License to Operate On-Site Sewage Treatment and Disposal Facility

113857

469 WEST OVERLOOK DR

DRIP TUBING SYSTEM

REVISED

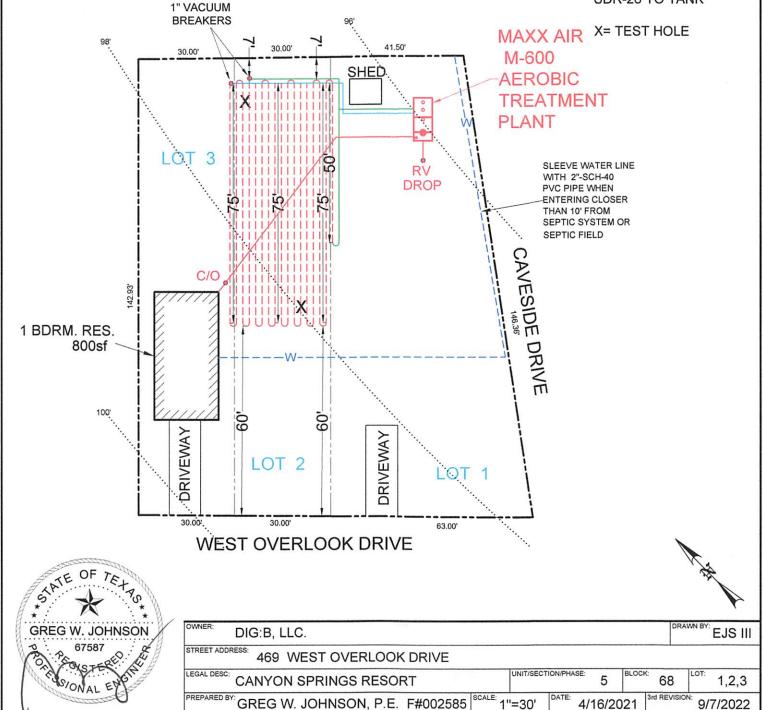
Greg,

The permit file has been updated. The installer will need to contract our office when ready for final inspection.

REVISED TO REMOVE DETACHED LIVING NOTE. THX, GREG

TYPICAL PUMP TANK CONFIGURATION NU-WATER 550PC -400PT 768 GAL PUMP TANK

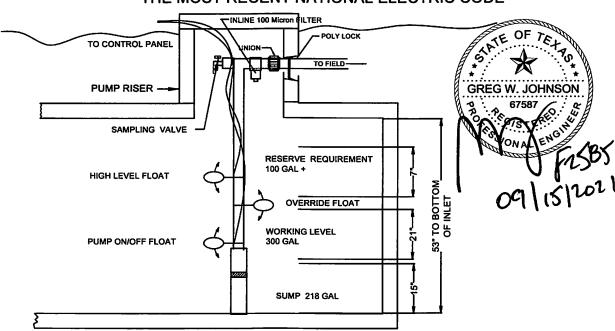
The permit tank detail sheet in the permit file is for a Nu-Water.

The system spec sheet and pump tank detail will also need to be updated to the Maxx Air ATU.

See attached.

VOID REVISED

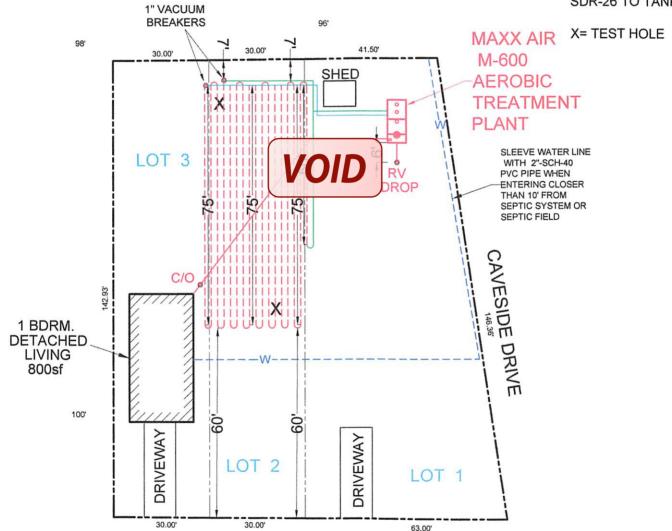
If the 1 bedroom will now serve as the single family residence, please revise the description.

Revised. Thanks, Greg
